**Co3265 – Pittsford-Brandon NH 019-3(494)**

**ADDENDUM #4**

Plan Sheets 30, 31, 32, 33, 36, 37, 226, 238, 256, 265, 270, 429, 432 & 433 have been revised.

PROJECT NAME: PITTSFORD - BRANDON	
PROJECT NUMBER: NH 019-3 (494)	
PROJECT LEADER: G. GOYETTE	DRAWN BY: D. BARNES
DESIGNED BY: D. YOULEN	CHECKED BY: I. MAYNARD
FILE NAME: d02bi98_typ.dgn	PLOT DATE: 4/10/2026
TTC PHASING TYPICAL SECTION SHEET 3	SHEET 433 OF 529

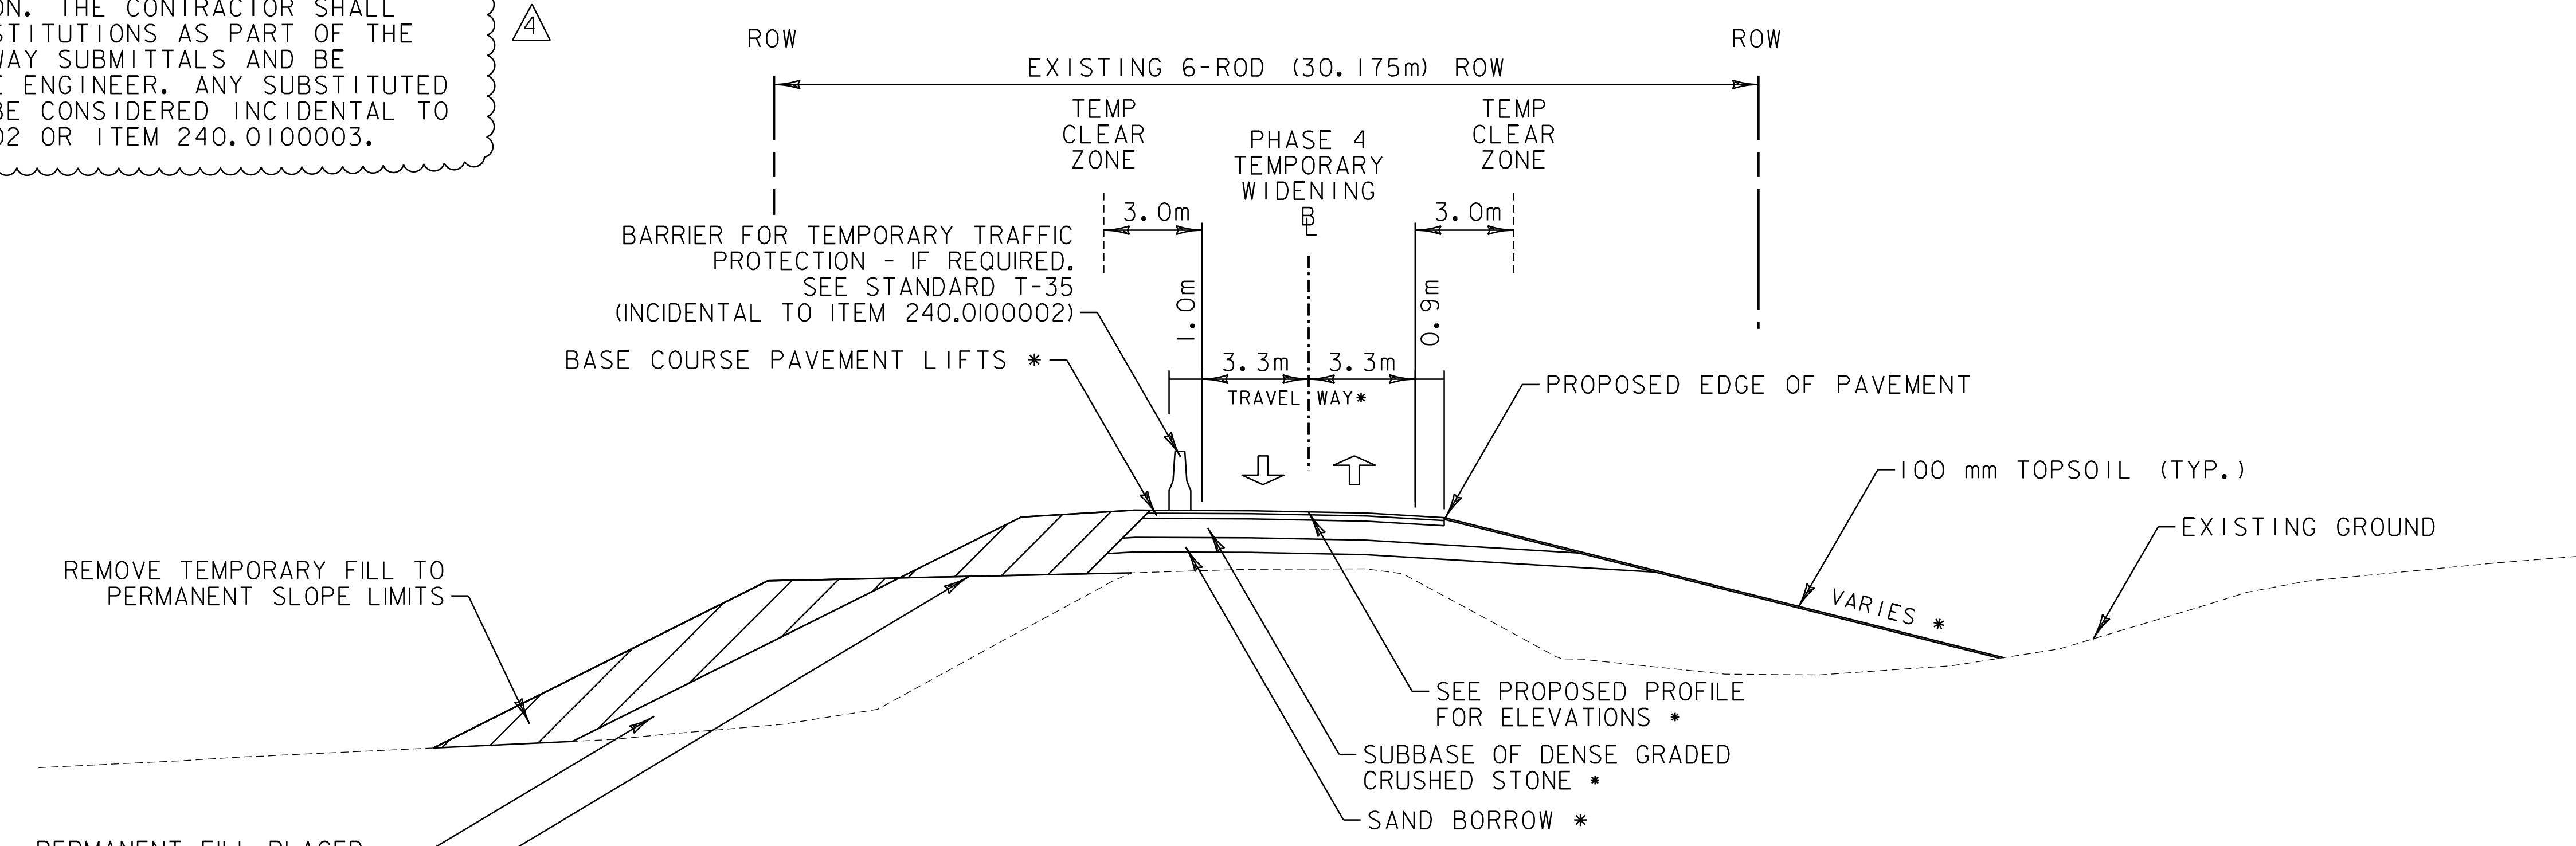
NOTE: THE CONTRACTOR MAY PROPOSE TO USE OTHER MATERIALS IN PLACE OF THE DENSE GRADED CRUSHED STONE IN THE TEMPORARY WIDENING AND/OR DIVERSION. THE CONTRACTOR SHALL SUBMIT ANY SUBSTITUTIONS AS PART OF THE TEMPORARY ROADWAY SUBMITTALS AND BE APPROVED BY THE ENGINEER. ANY SUBSTITUTED MATERIAL WILL BE CONSIDERED INCIDENTAL TO ITEM 240.0100002 OR ITEM 240.0100003.

ADDENDUM	REVISION	PLOT DATE	DESCRIPTION	BY
A	1	04-10-2026	NOTE ADDED	DMY
